Annex A-1

Plans and Minutes of Town Planning Board Meeting held on 8.5.2020 (Extracted)

**加路連山道用地的概念方案
CONCEPTUAL SCHEME FOR CAROLINE HILL ROAD SITE**

就黃泥涌分區計劃大綱草圖編號S/H7/20
提出的申述個案編號R1-R634及相關意見編號C1-C105作出考慮
CONSIDERATION OF REPRESENTATIONS No. R1-R634 AND
RELATED COMMENTS No. C1-C105 TO THE DRAFT
WONG NAI CHUNG OUTLINE ZONING PLAN No. S/H7/20

圖 PLAN
H - 5

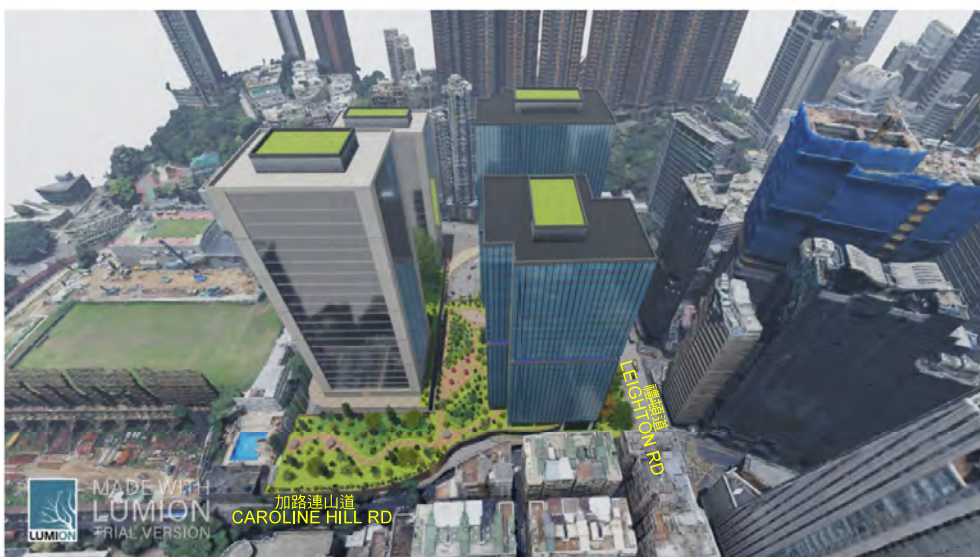
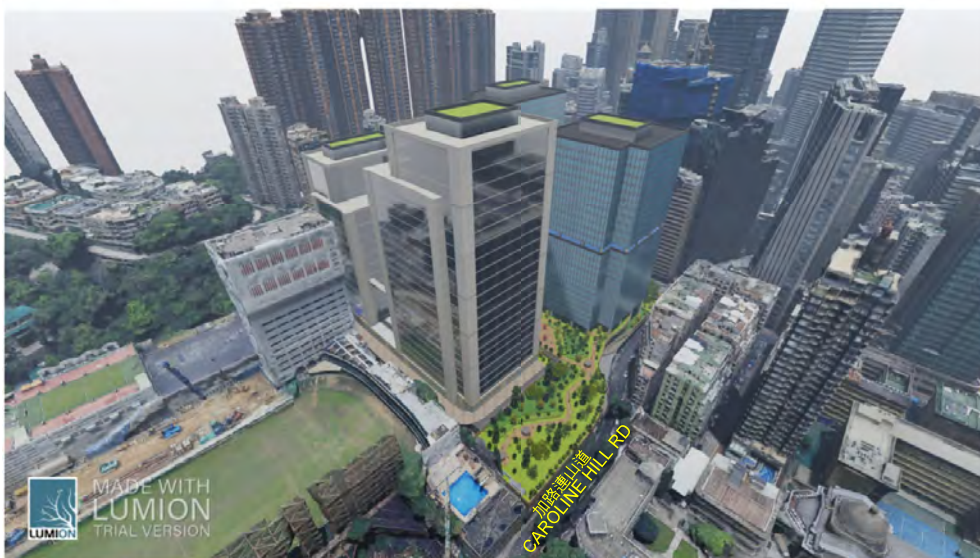
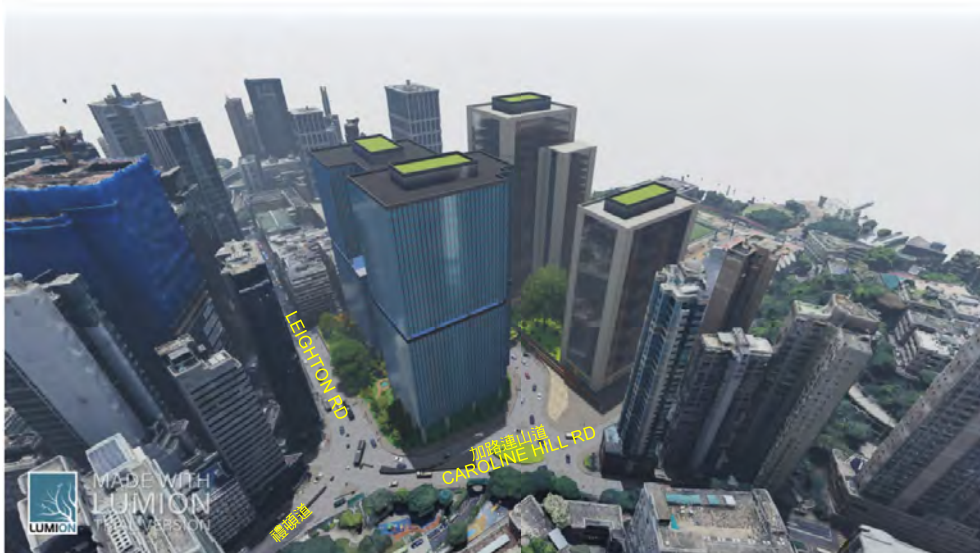
- (i) referring to the government scheme that a 25m-wide building gap had been provided within the site between the two commercial towers, whether the building gap of 20m between the district court buildings near CHR(West) and the residential development opposite them were sufficient, and whether the building gap could be widened;

- (m) whether there was scope to swap the location of the open space at the north-eastern corner of the site and the district court buildings.

- (a) the access road shown in the government scheme was indicative in nature. The future developer could consider different arrangements for the access road, including decking over it;

圖 PLAN
H - 7a

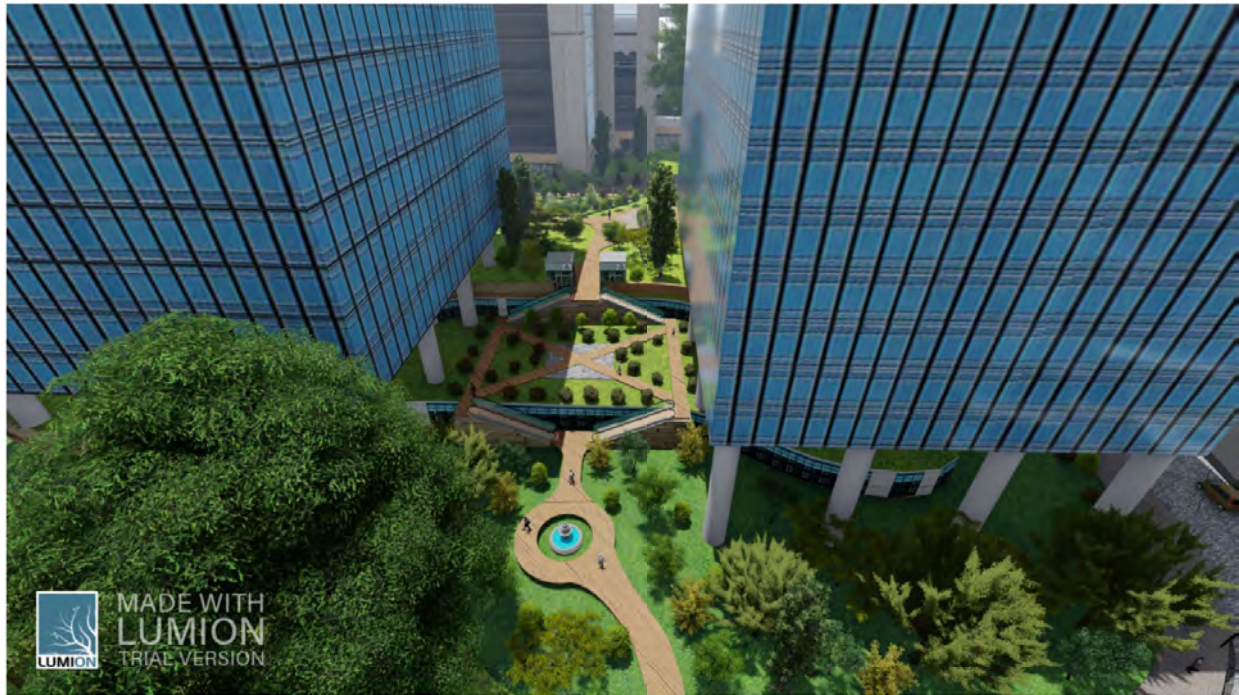
- (t) whether more open space could be provided notwithstanding that the OZP had stipulated a minimum 6,000m² of public open space and whether the management of the open space would be assigned to the future developer.
